SPECIAL PROCESS PROCEDURE

REPAIR AND CURING OF CONCRETE
REPAIR FOR PLACEMENT 95502-100

WATERFORD SES UNIT NO.3
CONTRACT NO. W3-NY-4

ERASCO QUALITY ASSURANCE

SK CH-163 REV 1

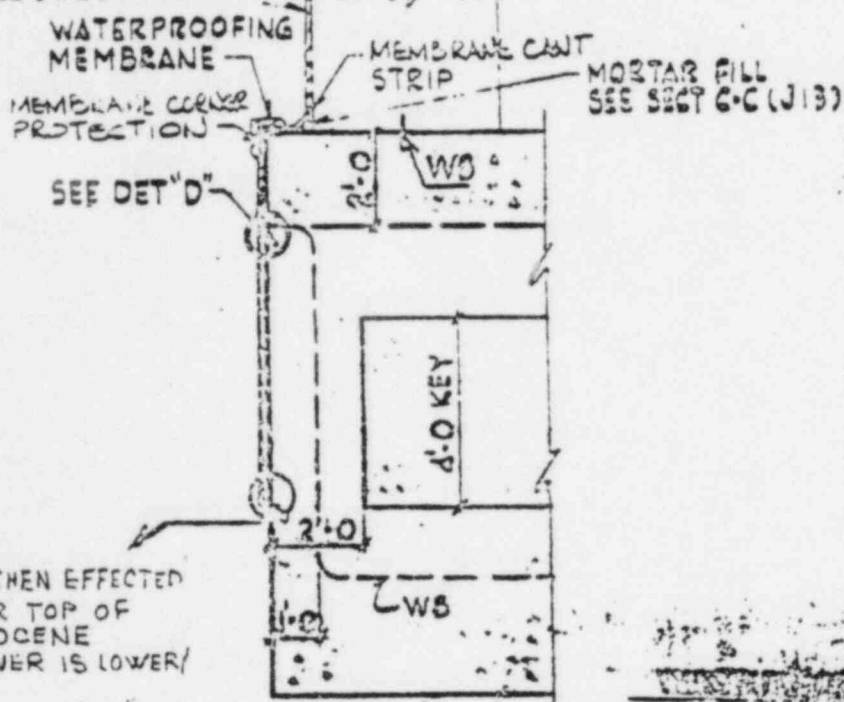
Attached is a revised sketch (SK CH-163, Rev. 1) detailing the extent of waterproofing required on the west face of foundation block 10B. Note that the waterproofing should extend below the effected area or to the top of the pleistocene whichever is lower. For ease of construction the reglet is to be cut horizontally into the concrete.

NOTE: ADD AN ADDITIONAL 12" OF
BITUTHENE WITH A BEAD AROUND
ALL EDGES AND PIPES.
